Addendum No. 1

Project: Whitlock Flexible Learning Center
Selective Roof Replacement and Selective Exterior Wall Repairs

WMBE Project Number: 2023-45

Addendum No.1 Questions and Answers

R-1.5

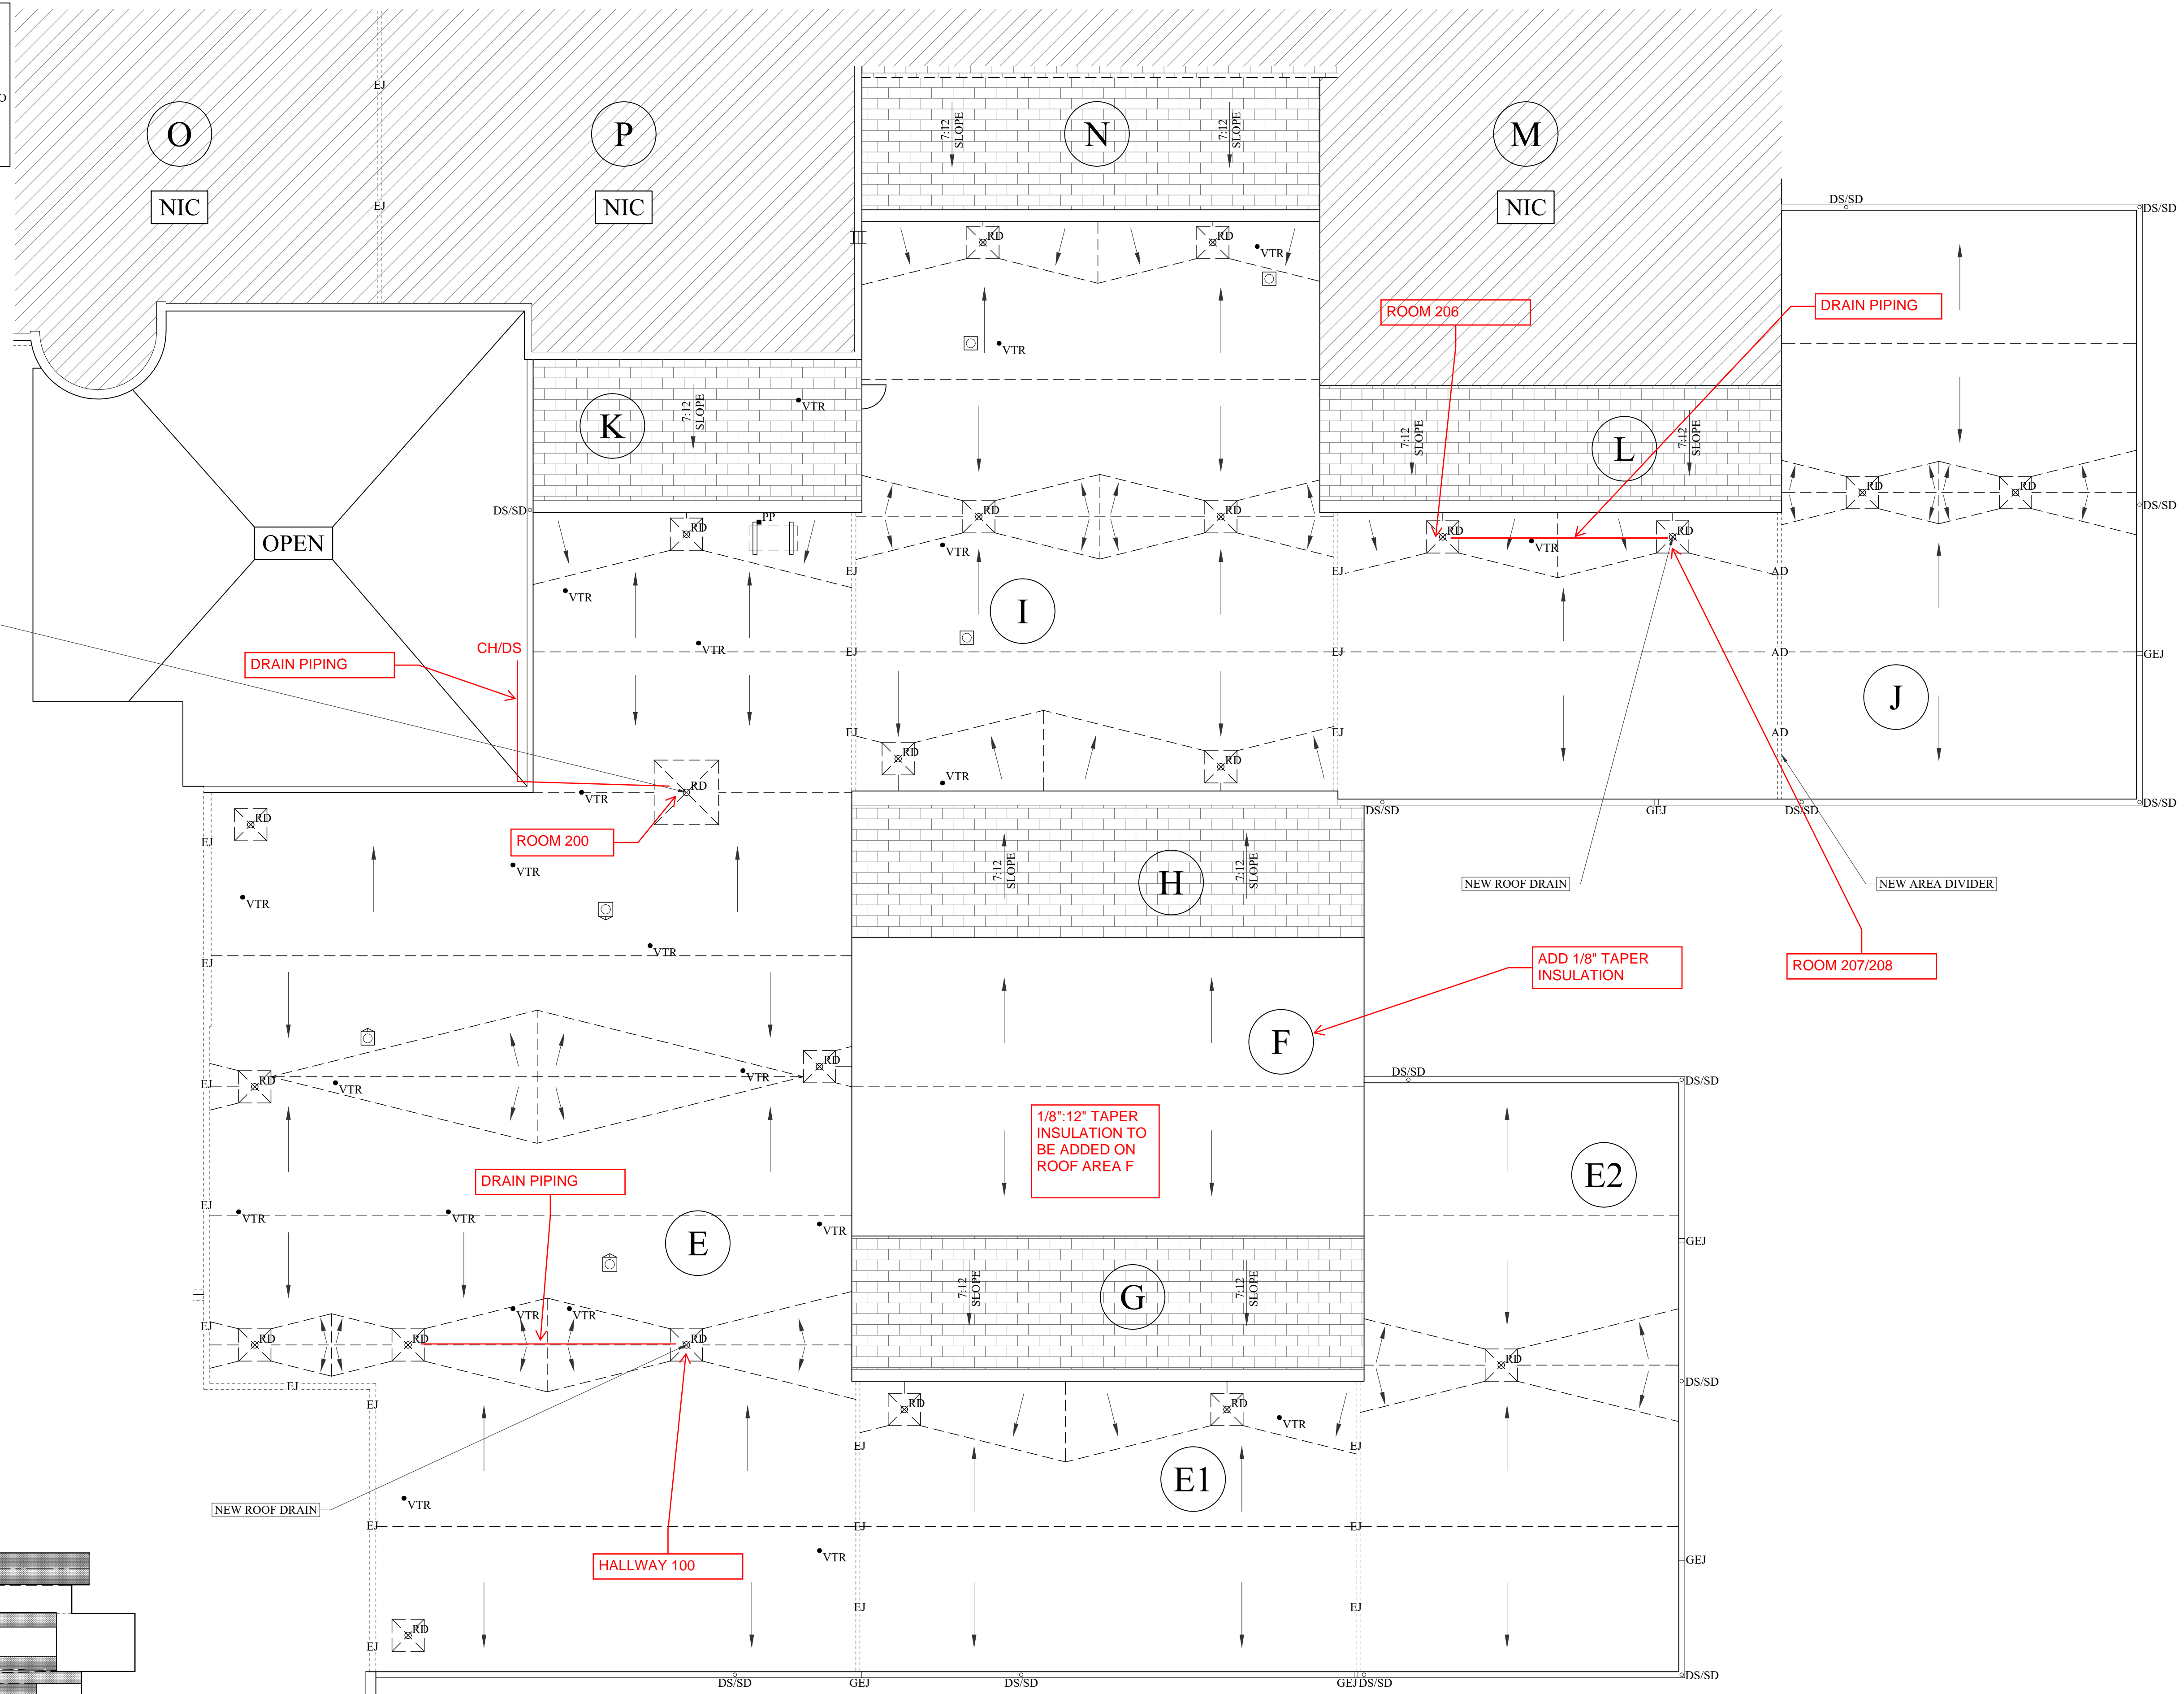
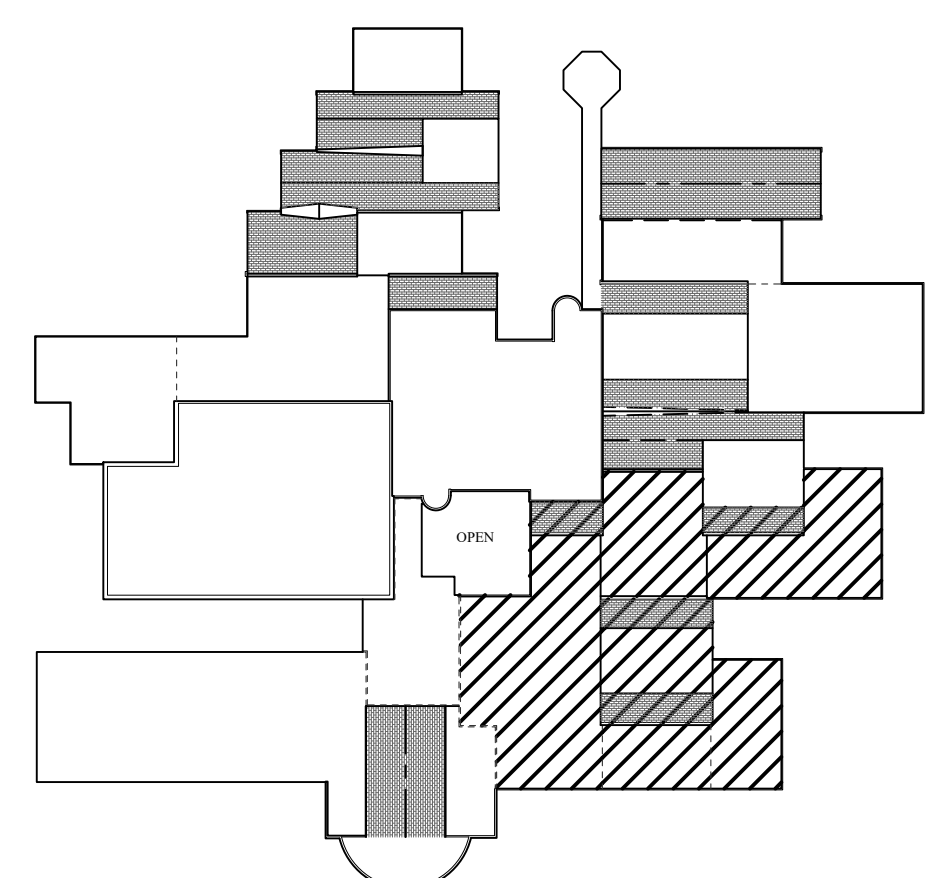
1. Changes to Bidding Requirements:
 - a. None
2. Changes to Specifications:
 - a. None
3. Changes to Drawings:
 - a. Drawing Page R -1.5

2. Question: Is taper insulation required ?

NEW ROOF DRAIN WITH 8' X 8' SUMP

ADD 1/8" TAPER INSULATION

1/8" - 12" TAPER INSULATION TO BE ADDED ON ROOF AREA F

NEW ROOF DRAIN

NEW AREA DIVIDER

Answer: Secondary taper at crickets and roof drain sumps. At roof area F, full taper insulation system to be provided at 1/8" : 12". See roof plan attached to addendum no.1
